July 18, 2016

North Carolina Department of Environmental Quality  
Division of Waste Management - Solid Waste Section  
217 West Jones Street  
Raleigh, North Carolina 27603

Reference: **Response to Comments on Landfill Permit Application**  
Edgecombe County C&D Landfill (Permit No. 33-01) Document ID No. 26274  
S&ME Project No. 1054-13-277A

FILLING PLAN - PHASES 6, 7, 8 AND 9

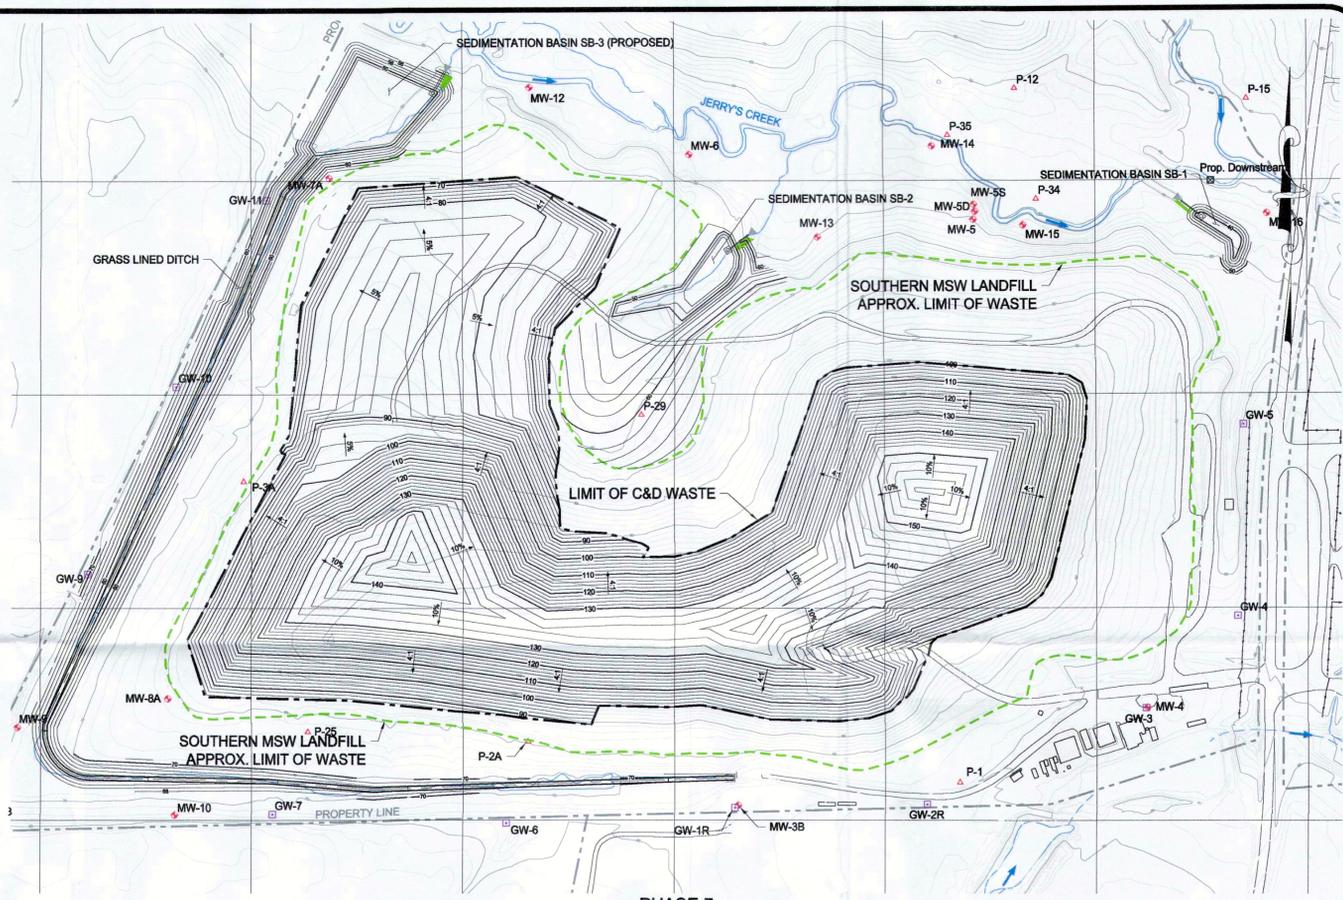
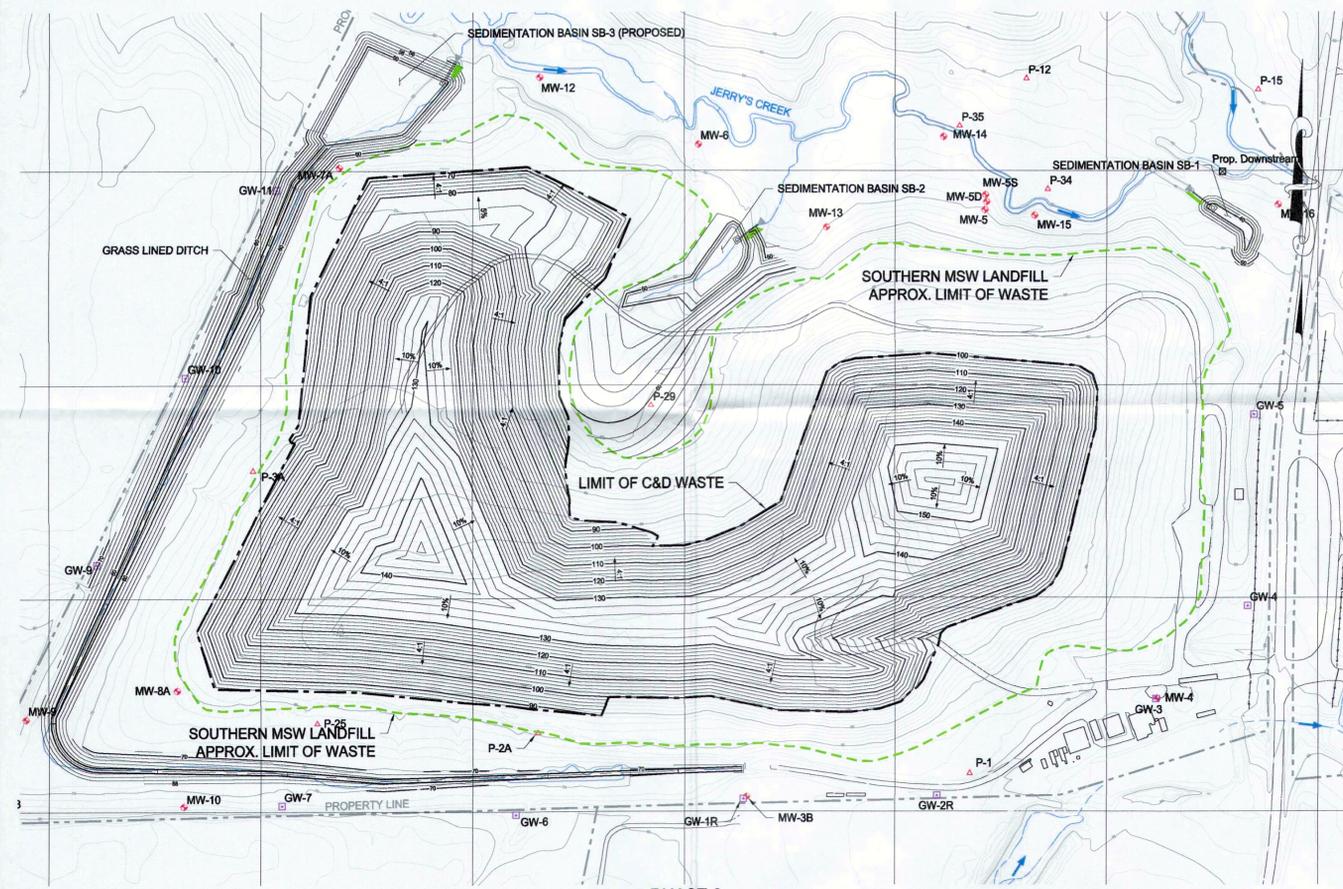
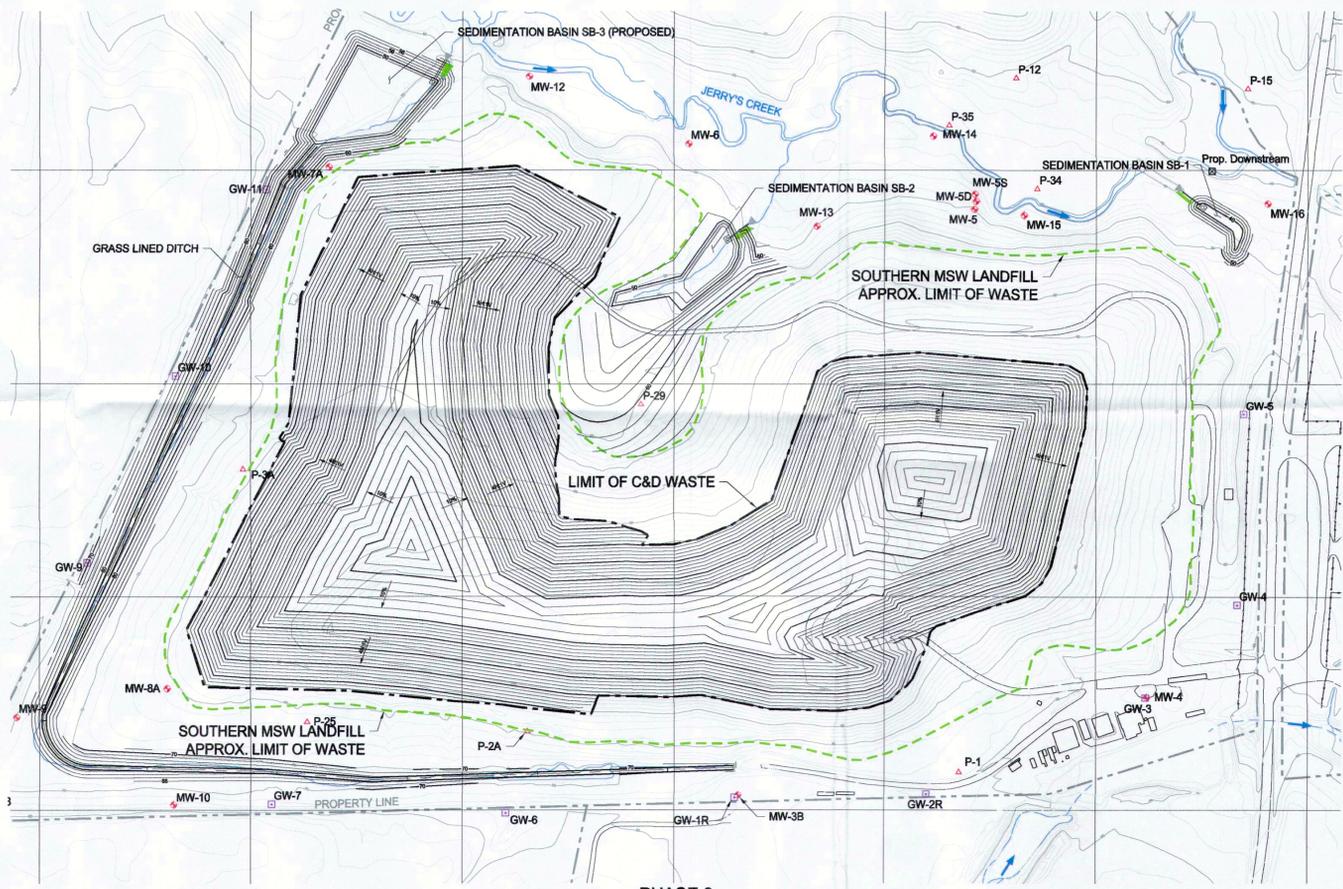
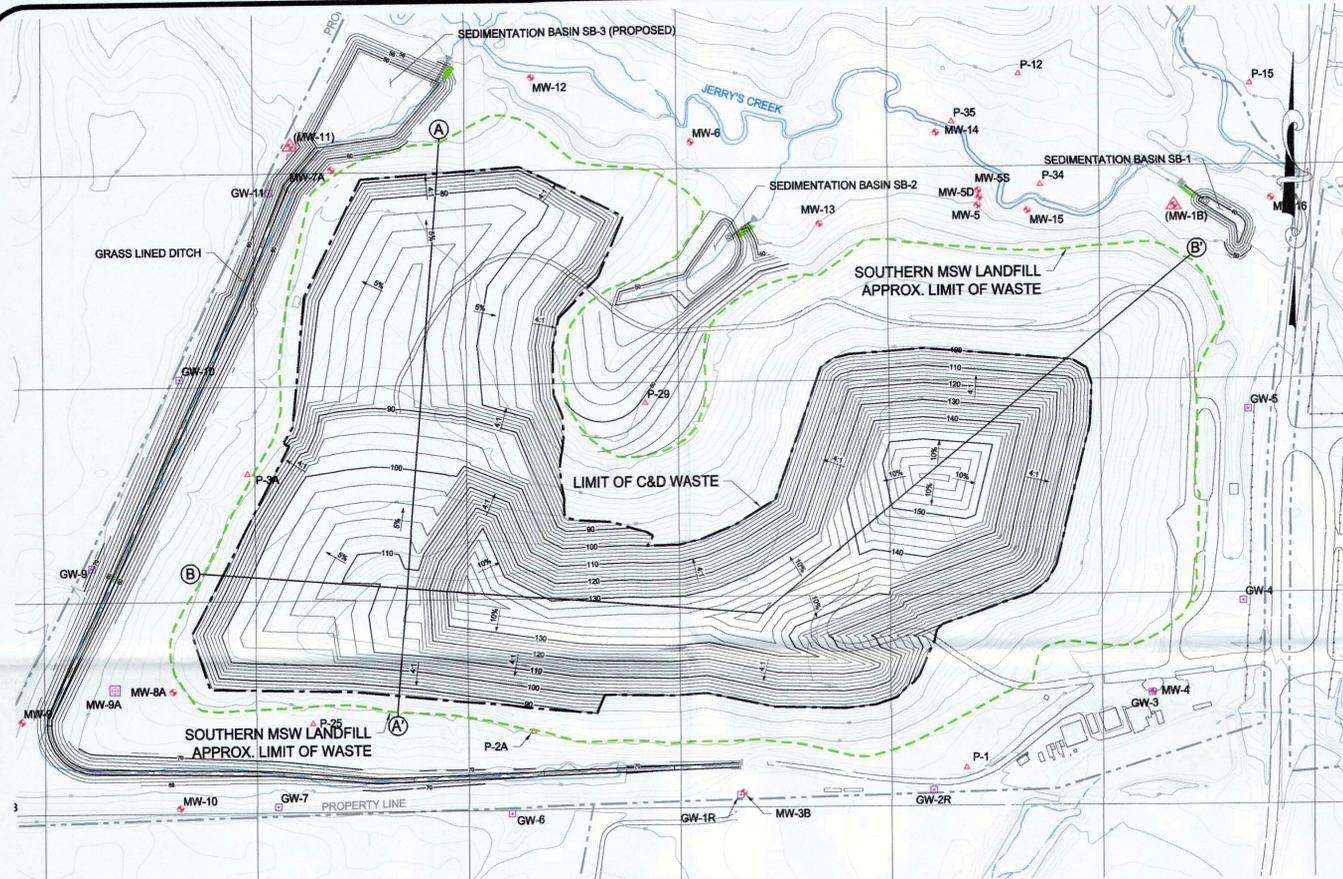
Phase 9 of the C&D Landfill is proposed in the Facility Plan and shown on the cross section on drawing, Drawing 7 of 13 in Section C- Operational and Waste Acceptance Plan. However, the Phase 9 waste footprint is not available on any other plan drawings. Please add the Phase 9 to the applicable drawings throughout the permit application document.

**The following drawings contained in the permit application have been revised to reflect Phase 9:**

**Section A - Facility Plan, Figure 5 of 8 – added plan view of Phase 9.**
